Long Point Outdoor Amenity Enhancement Project

Stage 1 Road Safety Audit

Galway County Council

August 2024

Figure 2.1 – Envelope of Visibility Looking to Right at New Car Park Access onto R351

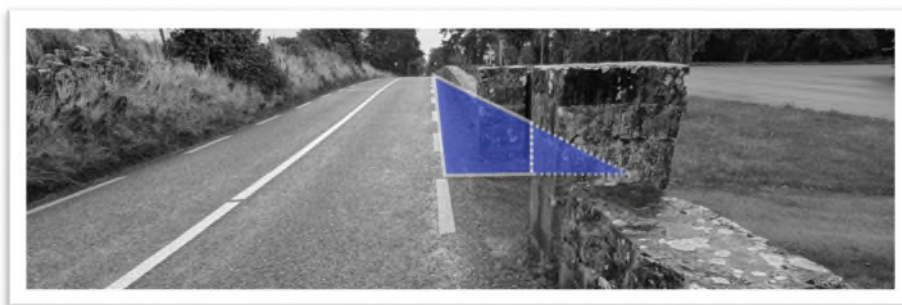
2.1 Problem: Driver’s Sight Line to Right at New Access

Location: Improved Access onto R351

The sight line for emerging driver’s looking to the right appears to be partially obscured by a crest in the road. This could mask the presence of an approaching vehicle, which might lead to an increase in the risk of a collision at the car park access.

Drivers should be provided with an appropriate envelope of visibility at the location described.

2.1	Yes	Yes	It is acknowledged that there is a crest in the R351 to the right (south) of the proposed car park access. For this reason a detailed assessment of the visibility in the vertical plane was undertaken, as shown in Figure B3 provided. The figure demonstrates that the 90m visibility, appropriate for the 60 kph speed limit, to an object height of 1.05m is available from the proposed access junction, in accordance with DN-GEO-03060 TII Geometric Design of Junctions.	Designer comment noted & accepted.

Figure 2.2 – Steep Approach to R351 Could Lead to Vehicle Stalls

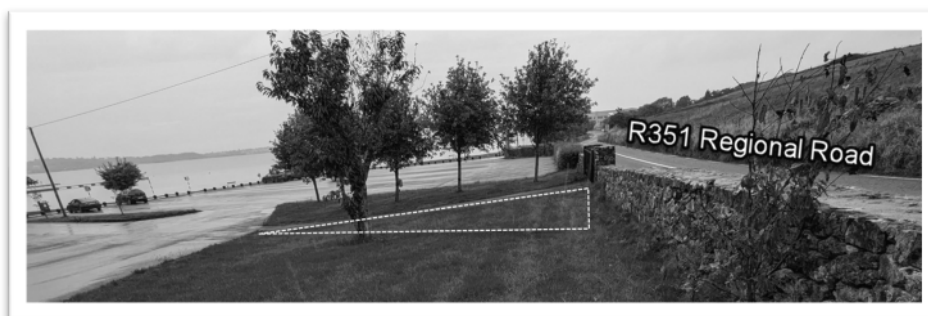
2.2 Problem: Up-Hill Gradient at Connection to Regional Road

Location: Main Vehicle Access Connection to Regional Road R351

The unusually steep uphill gradient could lead to vehicles either rolling back or stalling as they attempt to join the R351. This is likely to increase the risk of a collision at the car park access.

A suitable dwell area (i.e. a short section of road in advance of the stop line where the gradient has been reduced) should be provided on approach to the connection point to the R351 Regional Road.

2.2	Yes	Yes	An appropriate dwell area of 7m with a maximum gradient of 2% will be provided in accordance with Recommendations for Site Development Works.	Designer comment noted & accepted.

Figure 2.3 – Cycle Track Termination at Boundary of Car Park

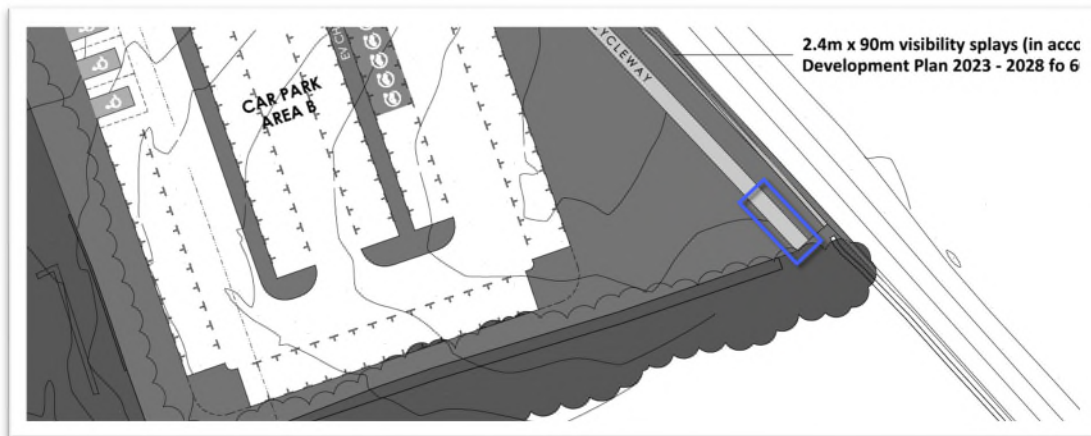
2.3 Problem: Abrupt Cycle Track Termination

Location: Cycle Track Termination at Southern Boundary

The abrupt cycle track termination could lead to frustration for cyclists resulting in poor decision making. It could also lead to cyclists entering the R351 without warning, increasing their likelihood of coming into conflict with a vehicle.

An appropriate cycle track transition should be made onto the R351.

2.3	Yes	Yes	It is noted that this section of the R351 is indicated as a "Cycle Connects Inter Urban Route" in the Loughrea Local Transport Plan. It is agreed that continuation of the proposed cycle facility through the Long Point site will require to be addressed as part of both proposals.	Designer comment noted & accepted.
